Project	<b>IEEE 802.16 Broadband Wireless Access Working Group</b> < <a href="http://ieee802.org/16">http://ieee802.org/16</a> >	
Title	<b>Proposed modifications to Subband Partioning to improve frequency diversity</b>	
Date Submitted	<b>2009-04-27</b>	
Source(s)	Mark Cudak, Fred Vook, Anup Talukdar, Bill Hillery, Fan Wang, Amitava Ghosh Motorola	Voice: +1 847 632 3160 E-mail: <a href="mailto:mark.cudak@motorola.com">mark.cudak@motorola.com</a>
Re:	Category: AWD comments / Area: Chapter 15.3.5 (DL-PHY) “Comments on AWD 15.3.5 (DL-PHY)”	
Abstract	The current DL PHY subband partitioning scheme has a problem where for high Subband Allocation Counts (SAC) the remaining subbands allocated to the miniband permutation have little to no frequency diversity. This is a problem as those remaining subband will be used for A-MAP whose performance would suffer. This contribution provides an alternate subband partitioning scheme that guarantees 4 <sup>th</sup> order frequency diversity for any value of SAC.

# Proposed Text of DL PHY Structure for the IEEE 802.16m Amendment

Figure A Current Subband Partitioning Scheme in 10r1

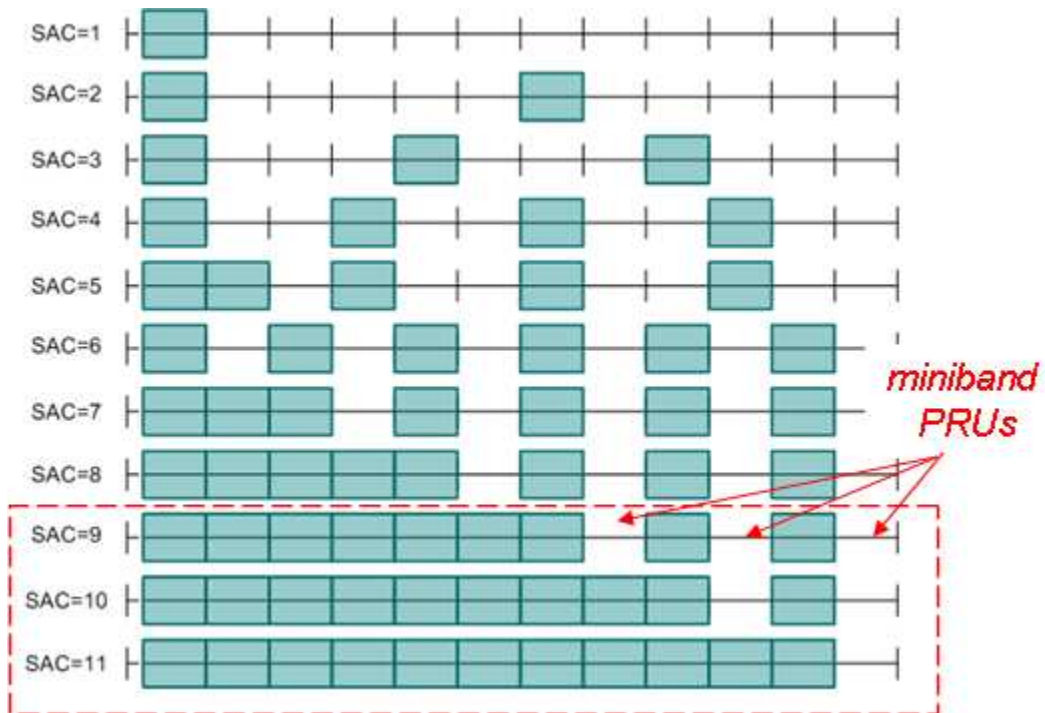
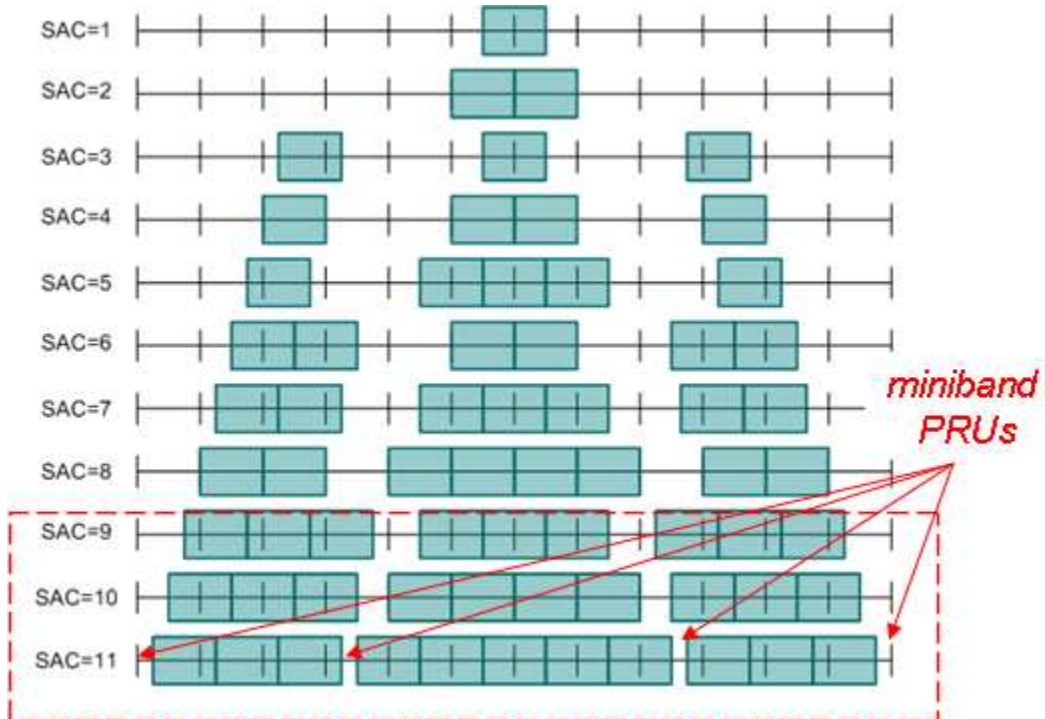
In the current subband partitioning scheme, PRUs assigned to miniband are always grouped in contiguous blocks of 4 PRUs. For small miniband allocations of 8 or 12 PRUs, less than 4<sup>th</sup> order frequency diversity is achieved. For allocations of only 4 miniband PRUs, no frequency diversity is achieved. Figure A illustrates the current subband allocation scheme. The white space shows where the miniband PRUs would be assigned. Notice for SAC=9 or greater the miniband PRUs have little frequency diversity

The proposed remedy allocates mini-band PRUs in 4 uniformly distributed points within the band such that a 4<sup>th</sup> order frequency diversity is guaranteed. Figure B illustrates the proposed subband partitioning scheme. Notice that, even for SAC=11, 4<sup>th</sup> order diversity always maintained.

Figure 408 PRU to DS-PRU and CS-PRU mapping for BW=5 MHz, SAC=3

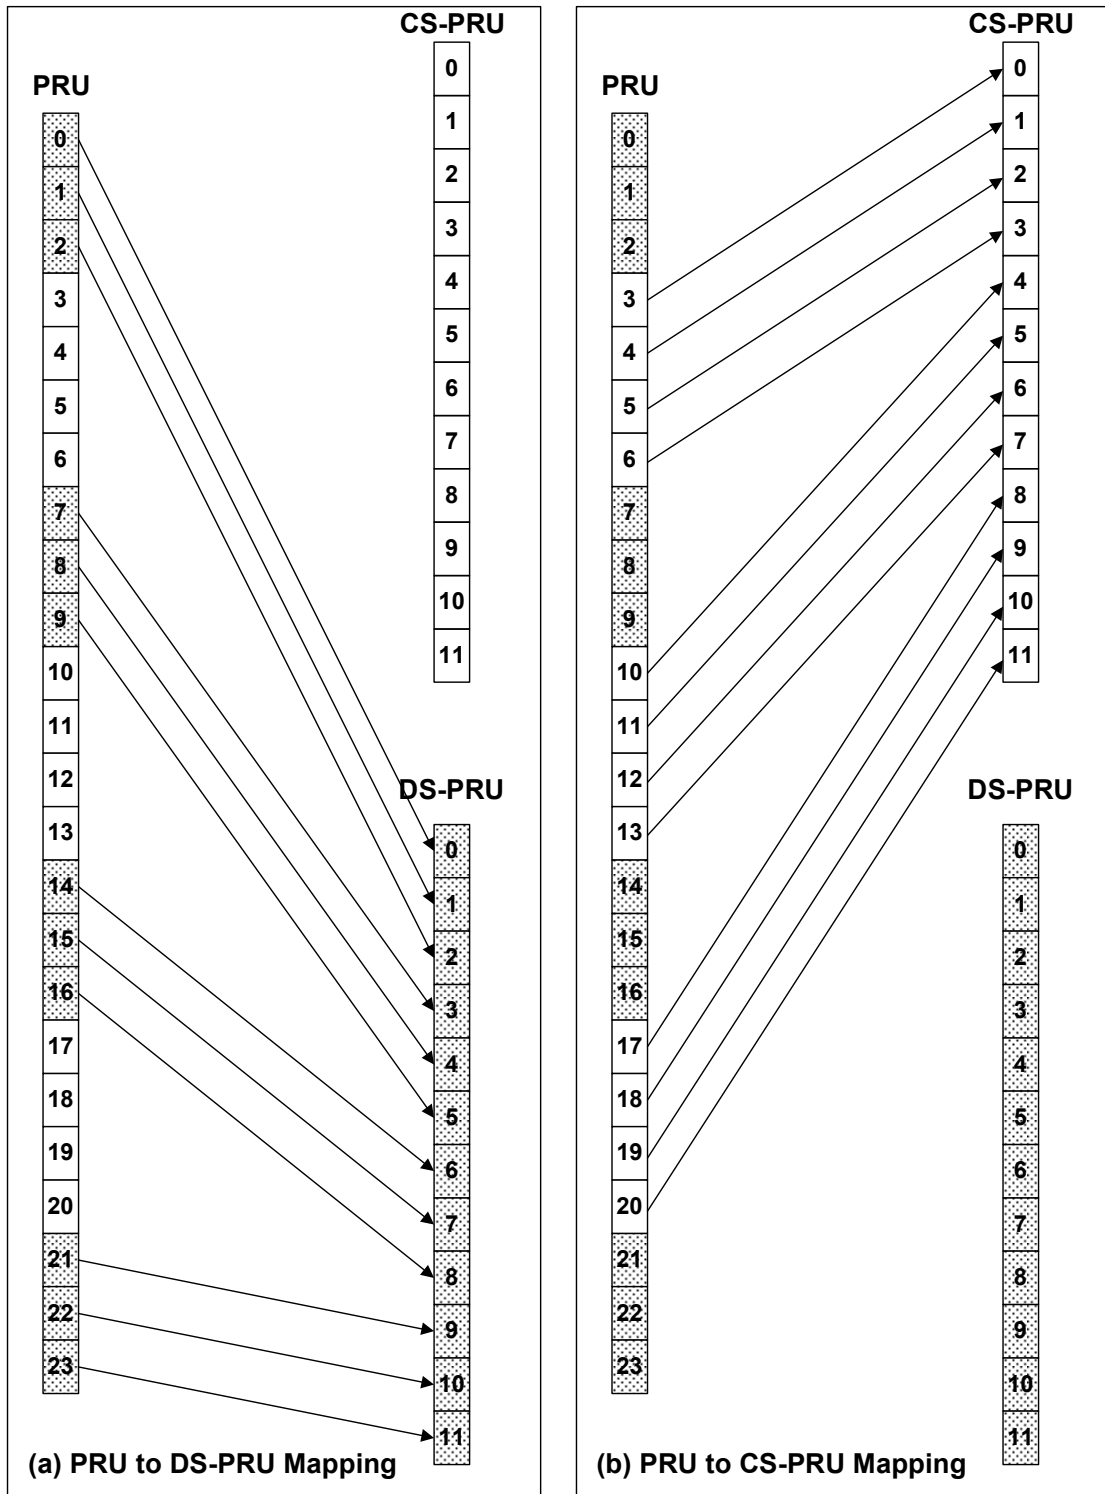
Replace Figure 408 with the following:
